STAGE 1 & 2 ROAD SAFETY AUDIT

SECTION 278 ACCESS WORKS, FIELD HEAD LANE, BIRSTALL

Job No: 26019

March 2026

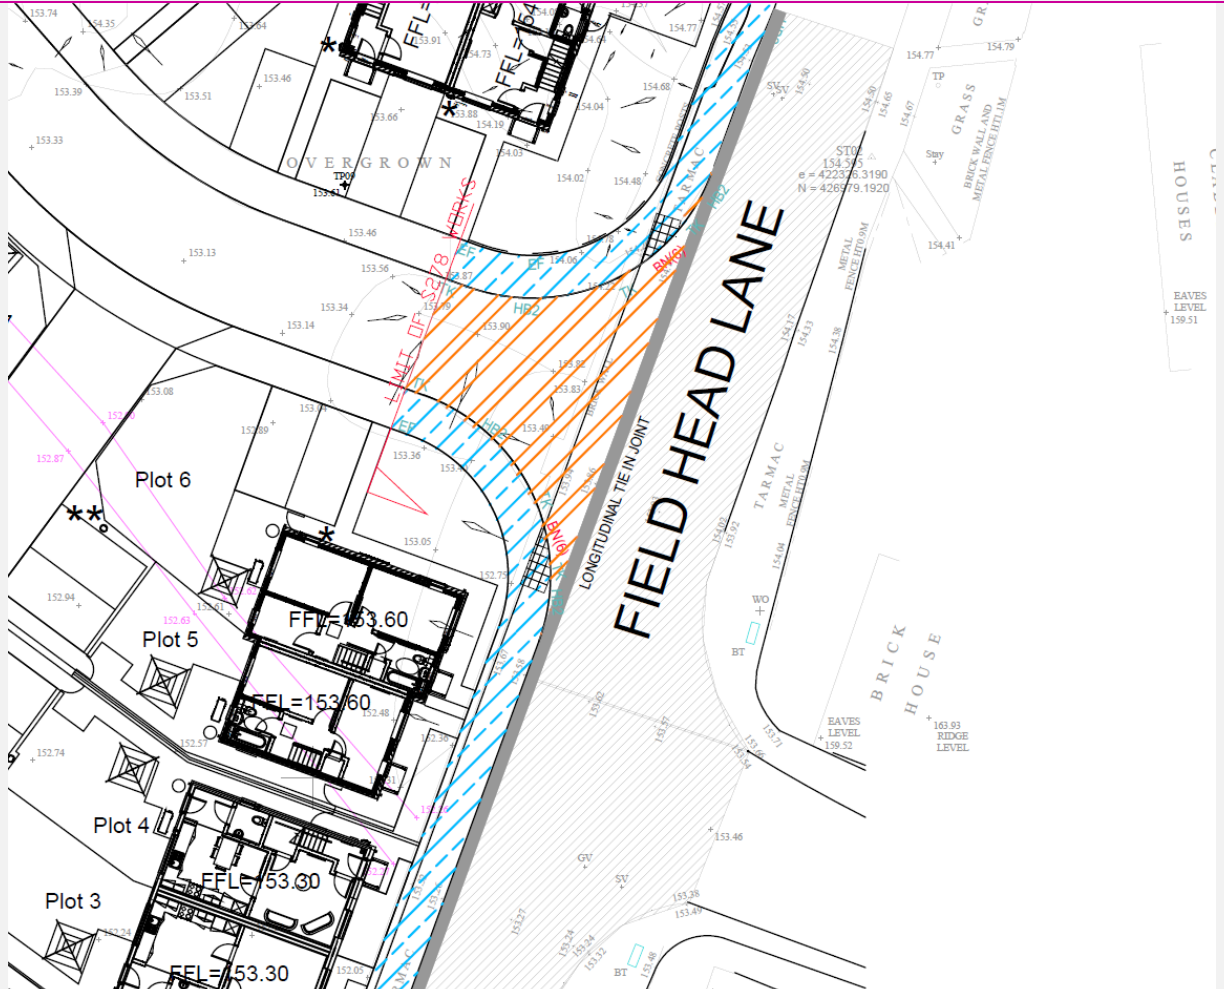
Problem 1	
Location	Site access off Field Head Lane.
Summary	No vehicle tracking analysis provided to demonstrate that there is sufficient carriageway available at the junction.
<p>It is not clear if there will be sufficient carriageway available to accommodate vehicle turning movements at the junction, particularly for large vehicles, if vehicles are parked directly opposite the junction on the east side of Field Head Lane. This will result in vehicles riding onto the footpaths and at risk of conflicting with pedestrians.</p>	
<p>The drawing is a detailed site plan showing four plots (Plot 3, 4, 5, and 6) and their access to Field Head Lane. Plot 3 has a Finished Floor Level (FFL) of 53.30. Plot 4 has an FFL of 53.30. Plot 5 has an FFL of 53.60. Plot 6 has an FFL of 53.60. Field Head Lane is shown as a road with a longitudinal tie-in joint. The drawing includes various annotations such as 'LIMIT OF FINISHED FLOOR LEVELS', 'LONGITUDINAL TIE-IN JOINT', 'FIELD HEAD LANE', 'BRICK HOUSE', 'TAR MAC', 'METAL RESURFACING', 'GRASS', 'BRICK WALL AND METAL RAILING', 'EAVES LEVEL', and 'HOUSES'. Yellow lines indicate vehicle swept paths at the junction. A stationing point is noted as 'STN 134.575 ± 422379.3190 N = 428979.1920'.</p>

Recommendation	
<p>It is recommended that vehicle tracking is undertaken and or waiting restrictions (yellow lines) are provided at the access junction to ensure that there is sufficient carriageway area available to accommodate all vehicle turning movements on and off Field Head Lane.</p>

DART HAVE UNDERTAKEN TRACKING AS SHOWN ON DRAWING 25469-DR-C-0136 P2 S278
VEHICLE SWEEP PATH TRACKING
